**HISTORIC PRESERVATION BOARD
REVISED APPLICATION**

05/14/2024

PREPARED BY:
**JAMES
CORNER
FIELD
OPERATIONS**

LINCOLN ROAD DISTRICT IMPROVEMENTS PHASE 3

LINCOLN ROAD- 400 BLOCK
REVISED GATEWAY SIGN DESIGN (05/14/2024)

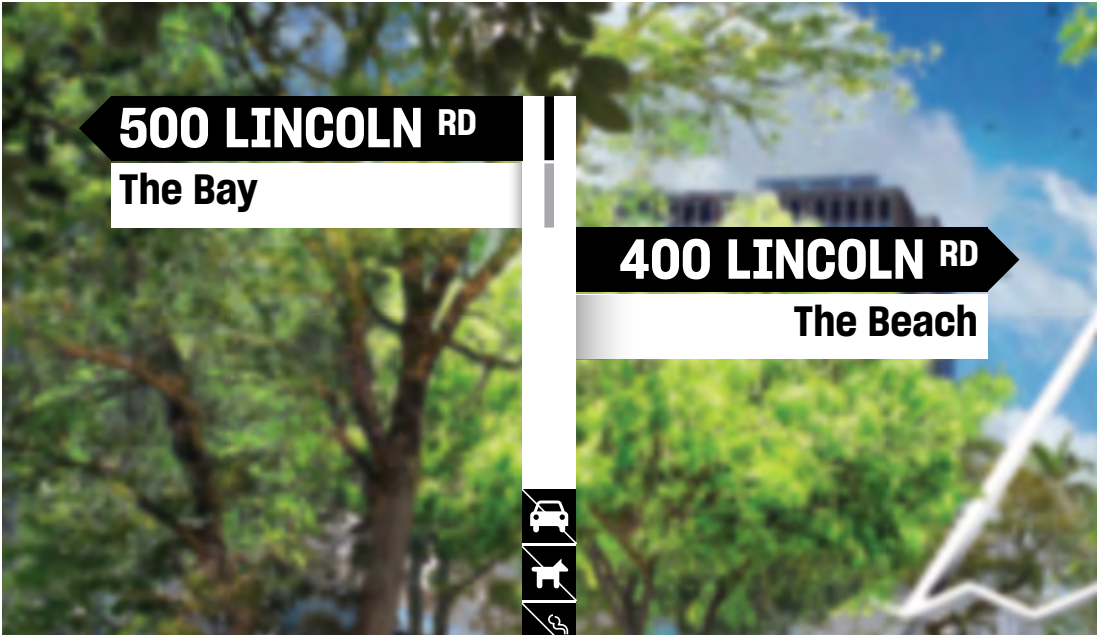
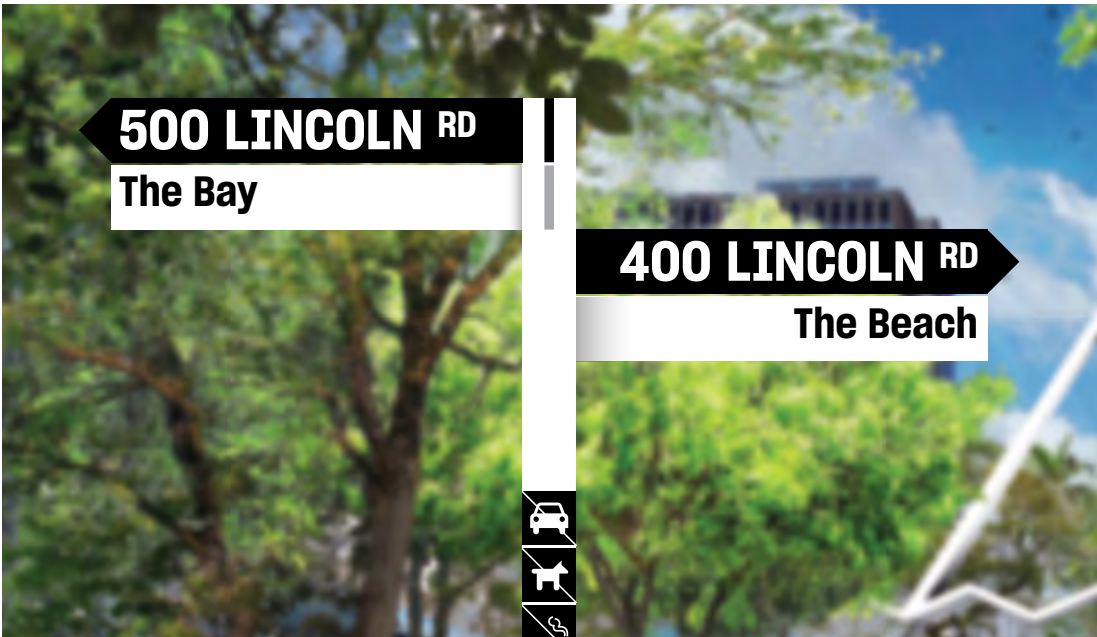
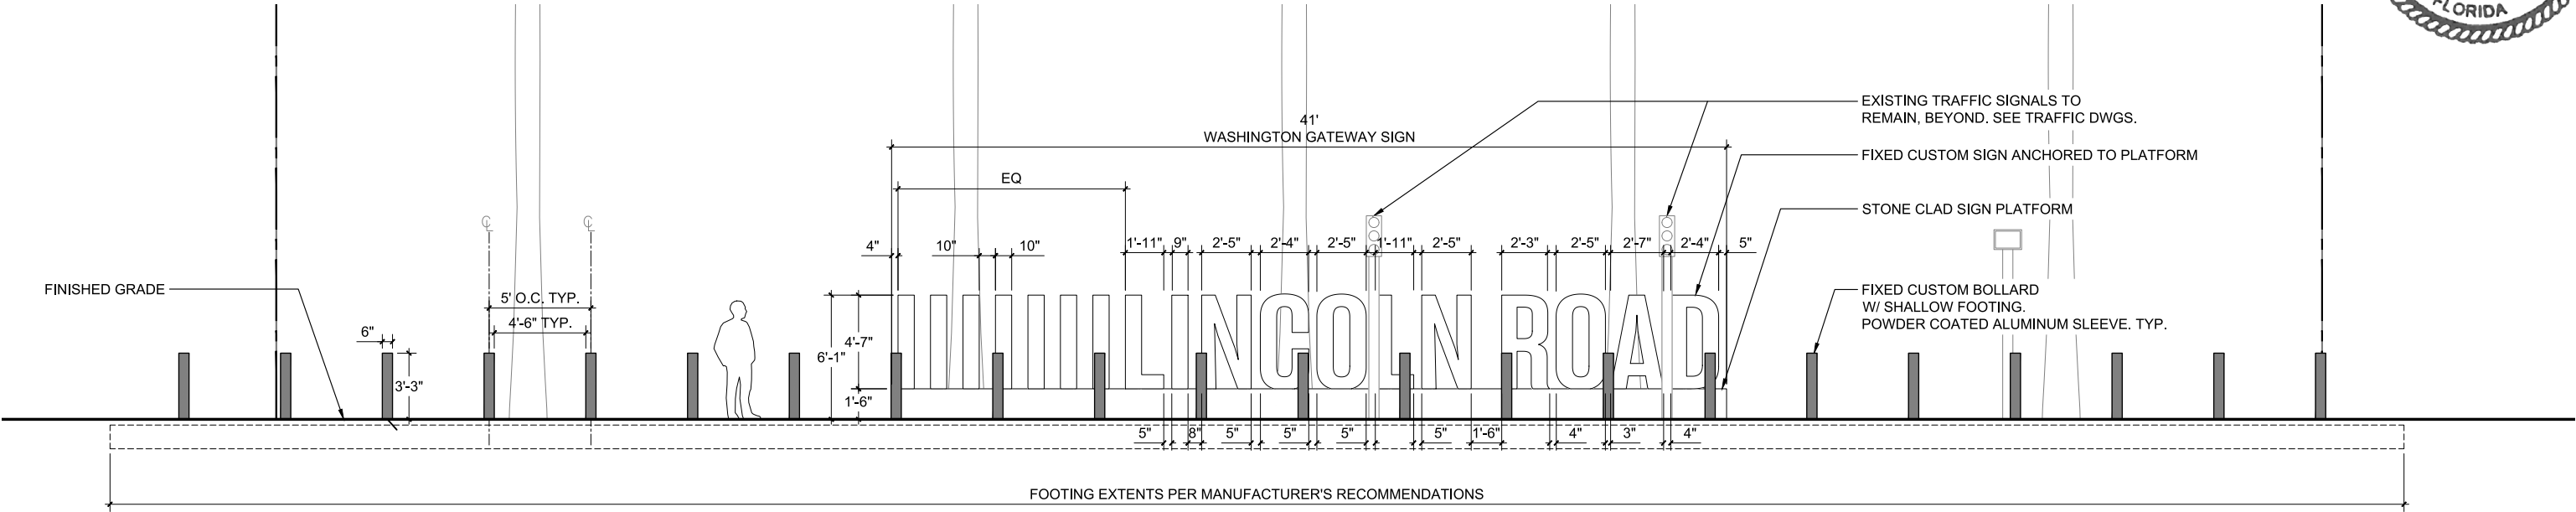
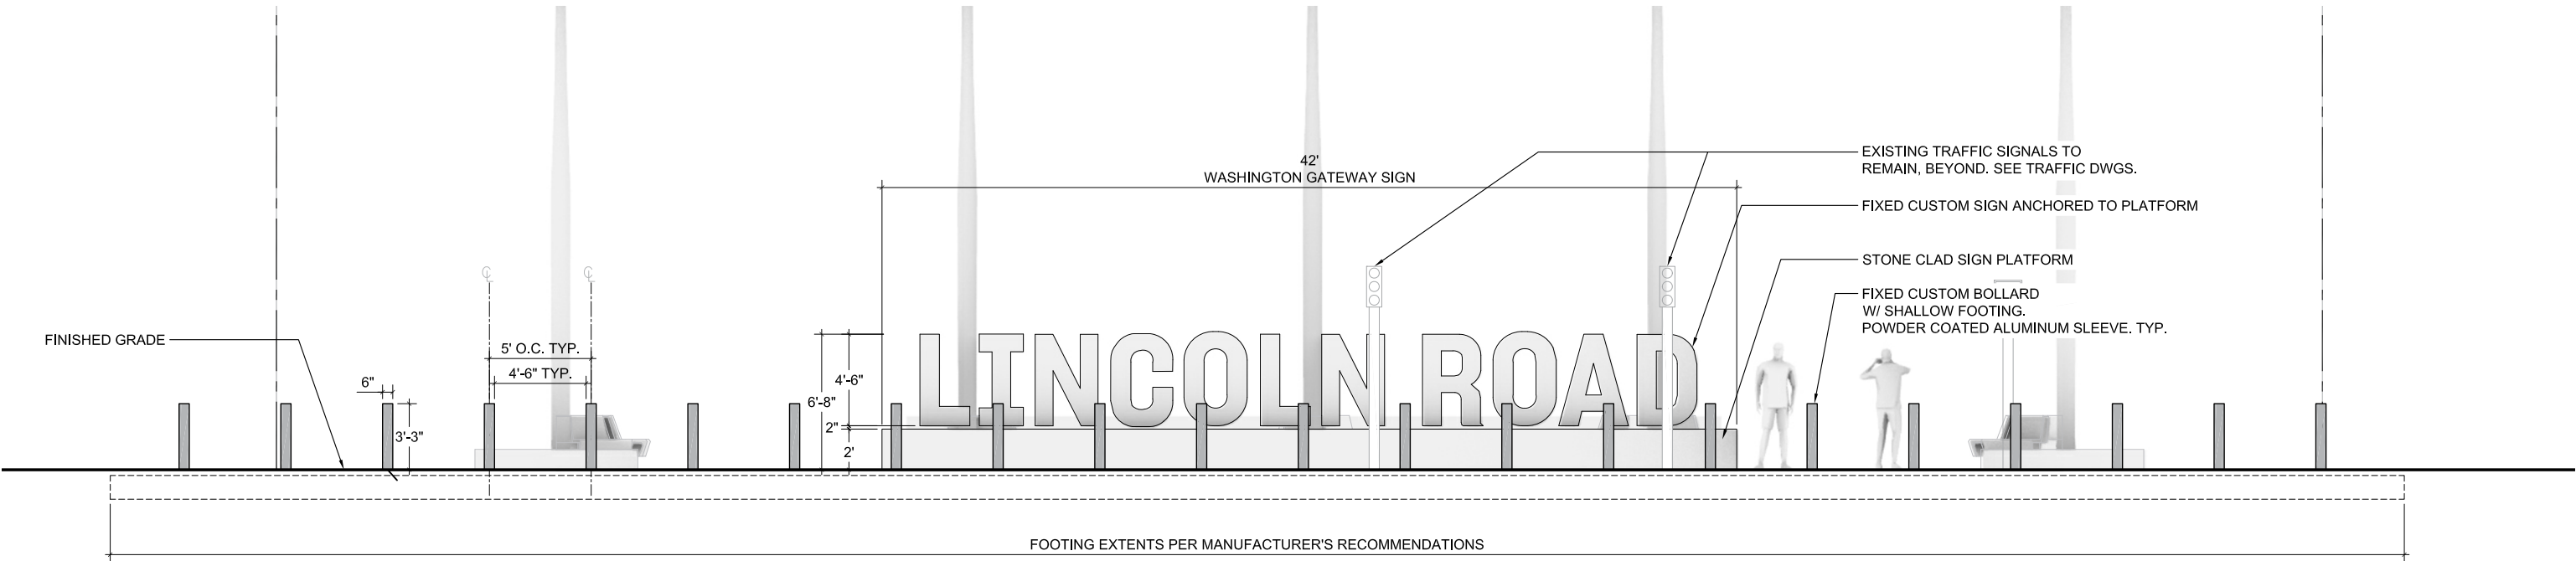
GATEWAY SIGN- REVISIT TO BETTER ALIGN WITH WAYFINDING TYPOGRAPHY

ELEVATION
PREVIOUS SIGN AT WASHINGTON AVENUE (02/13/2024)

ELEVATION
REVISED SIGN AT WASHINGTON AVENUE (05/14/2024)

EUCLID OVAL
SCALE COMPARISON REVISED (05/14/2024)

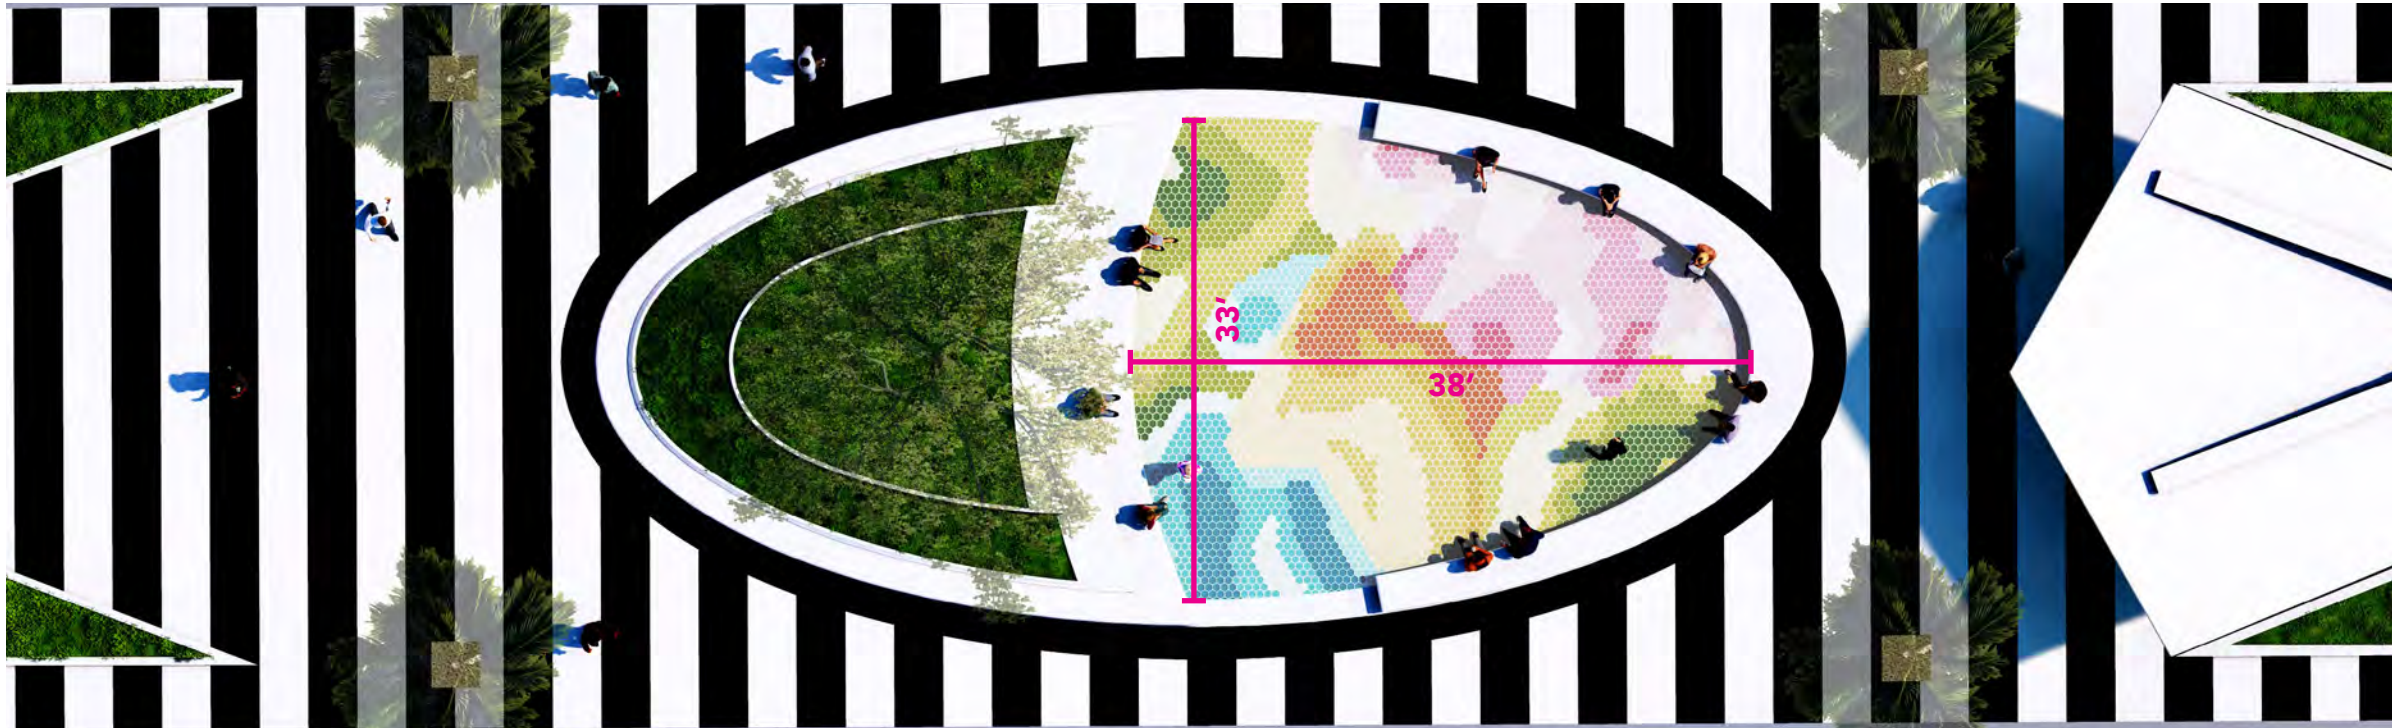
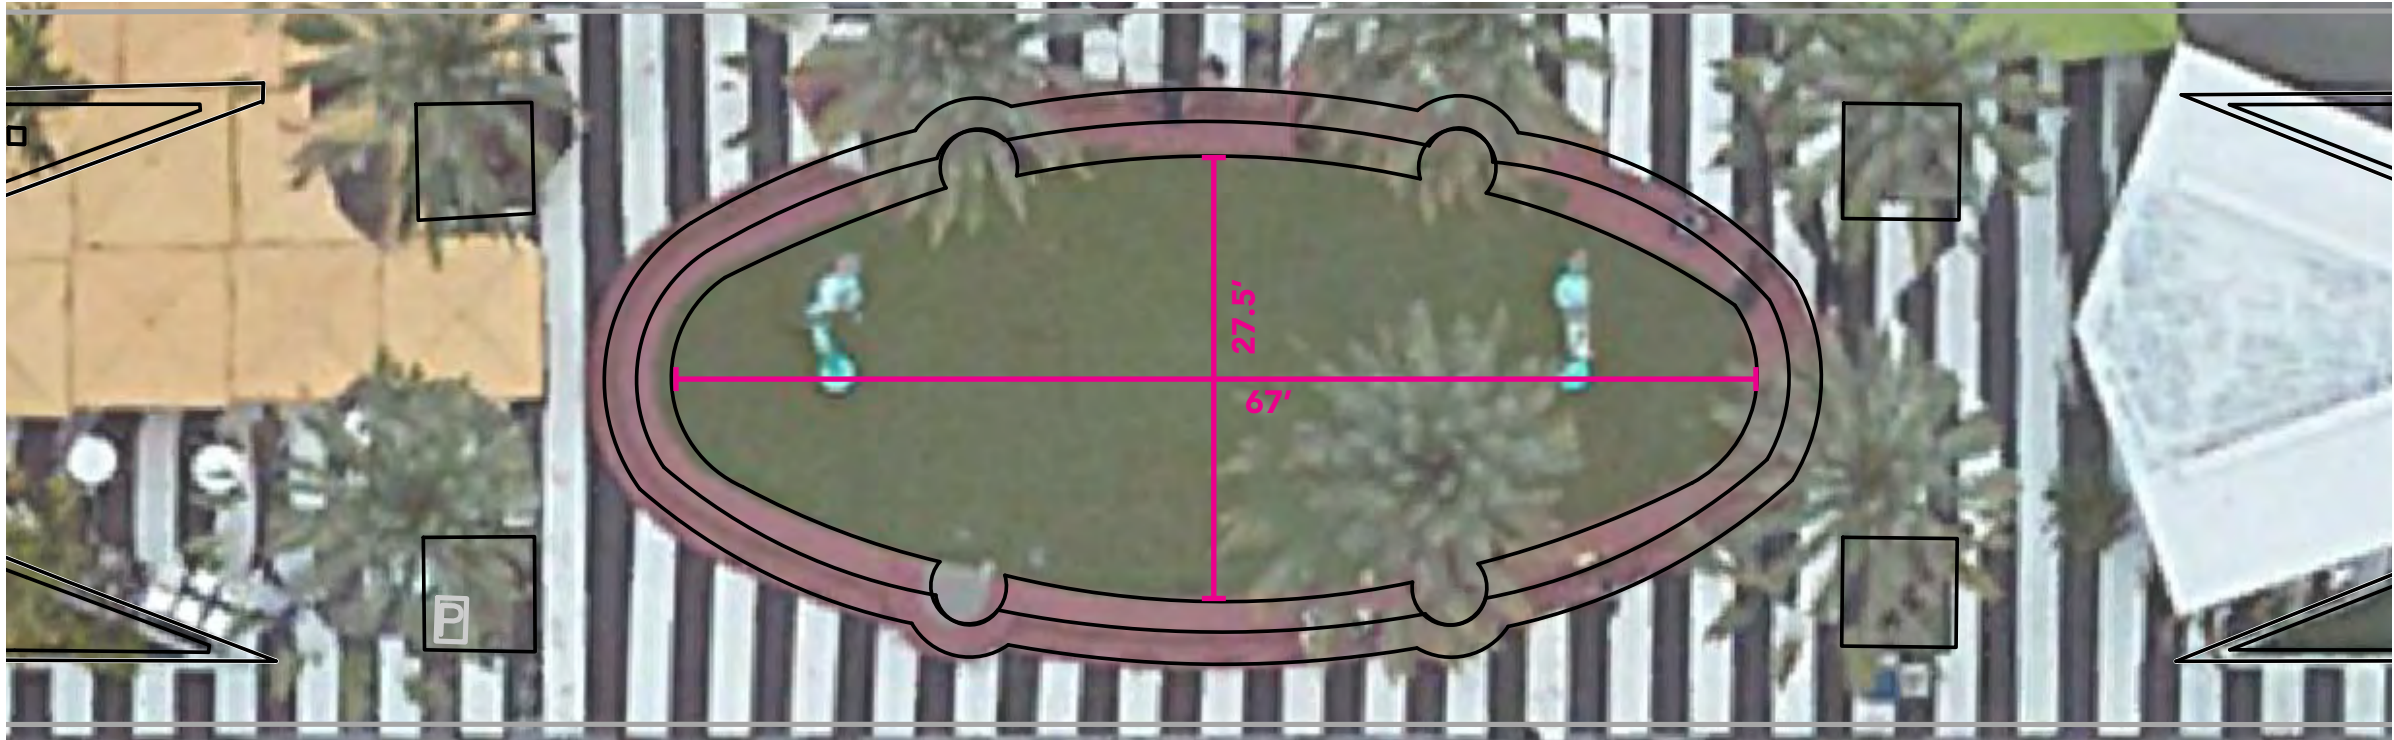
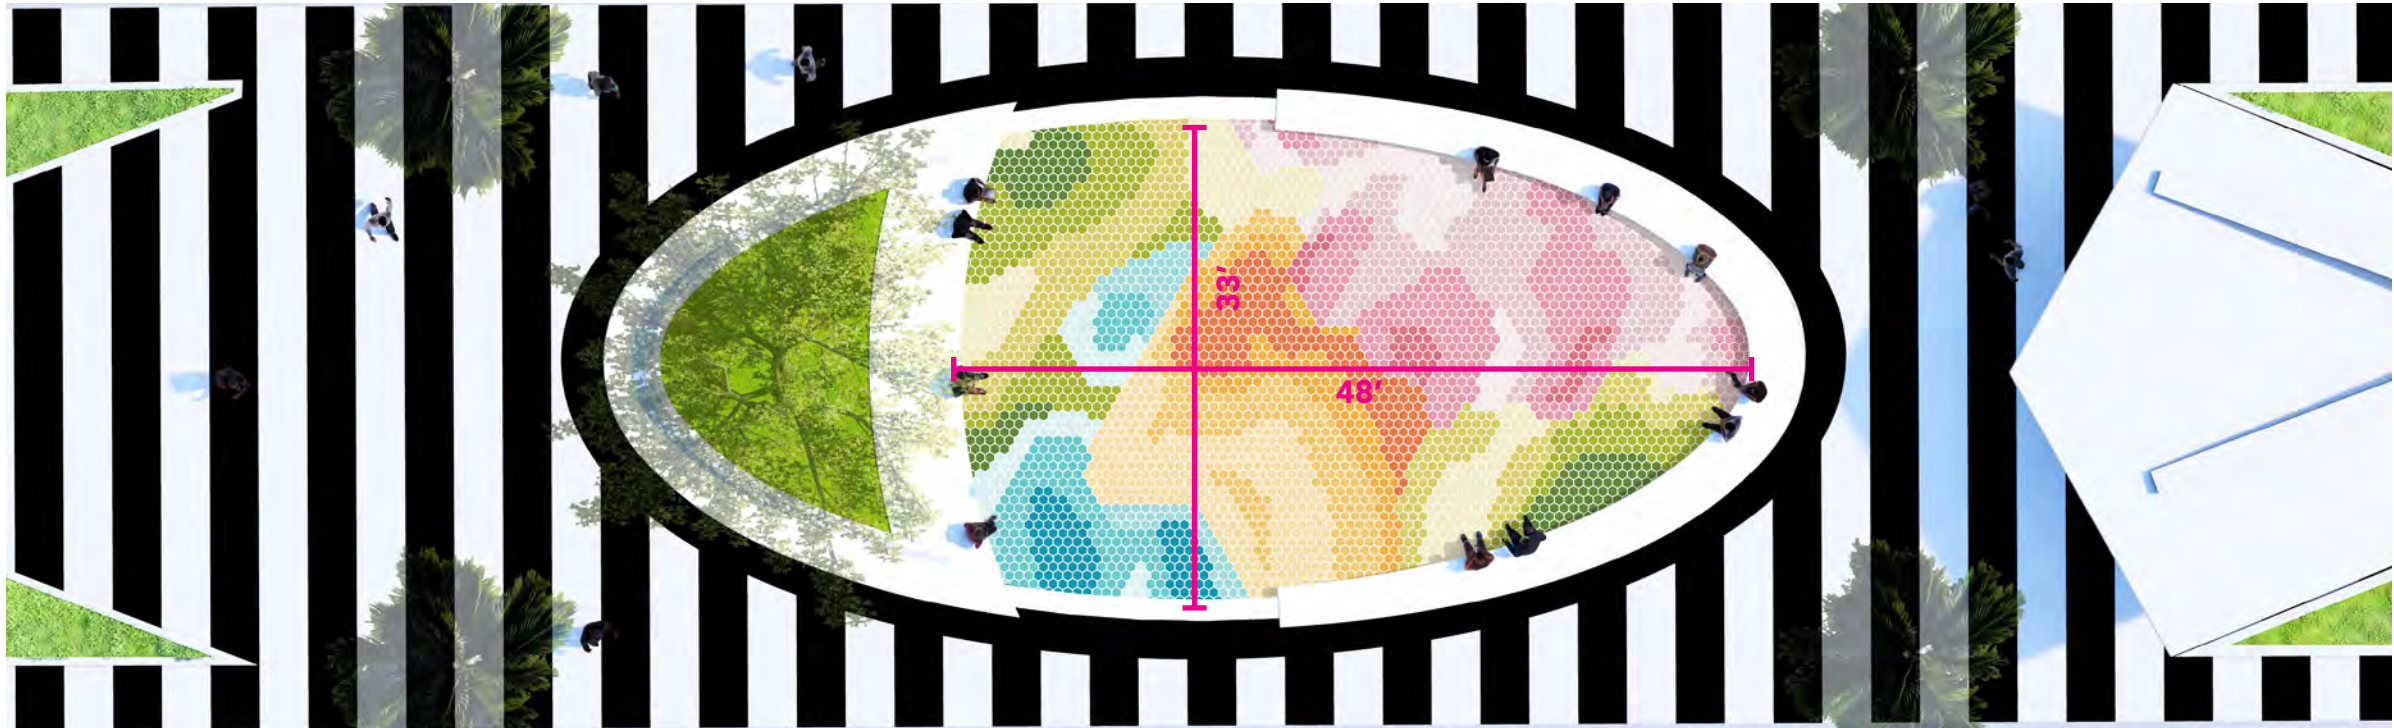
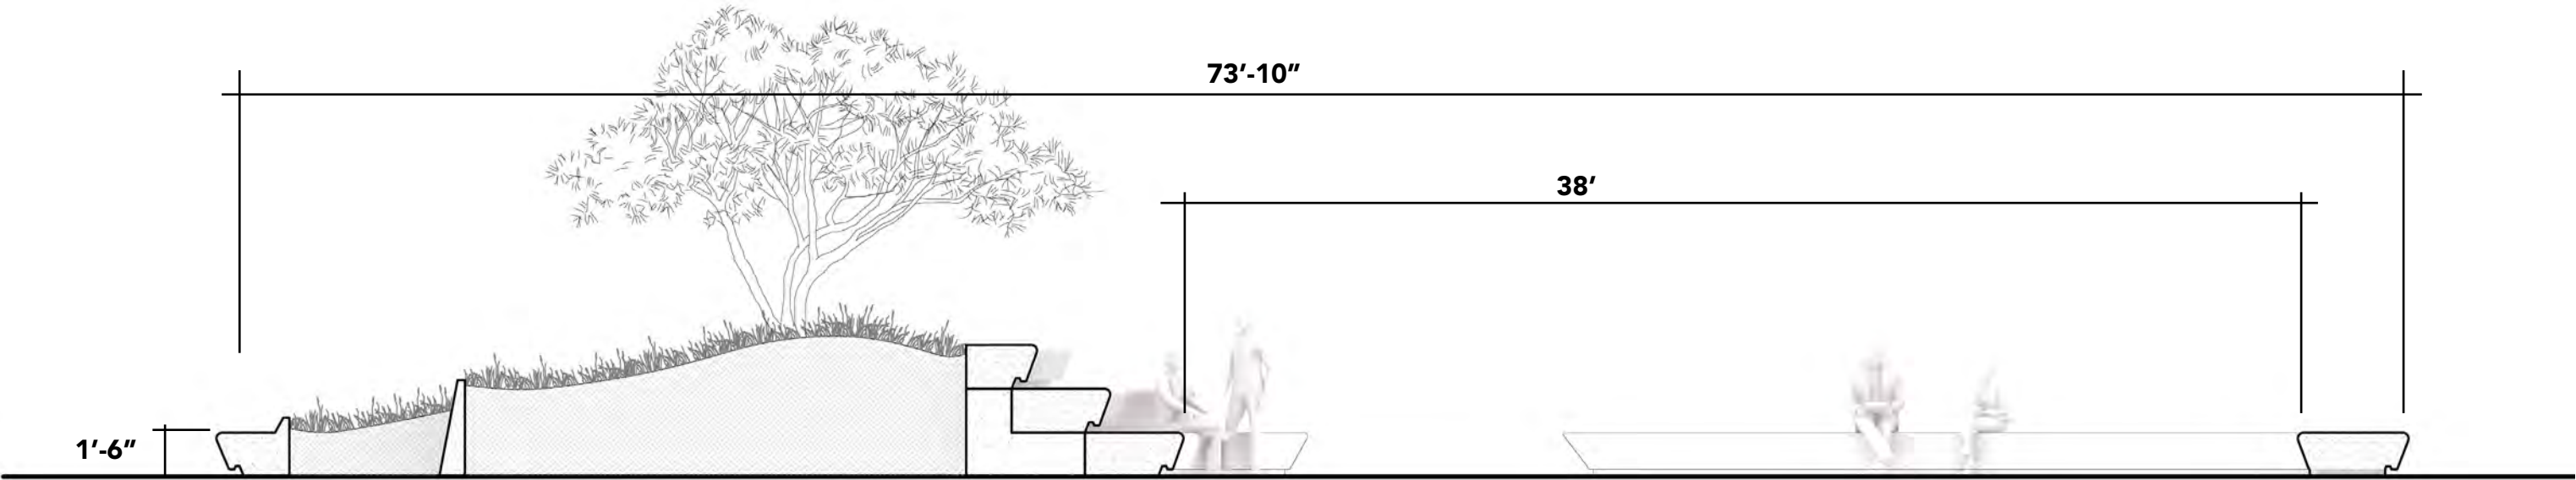
SIZE- REVISIT PROPORTION OF FLEXIBLE AREA AND PLANTER TO ENSURE AREAS CAN FIT CURRENT EVENTS AND INSTALLATION AND PROVIDE COMPARABLE FLEX SPACE

PROPOSED PLAN 05/14/2024
1,181 SQ FT

REVISED EUCLID OVAL DESIGN (05/14/2024)
1,181 SQ FT
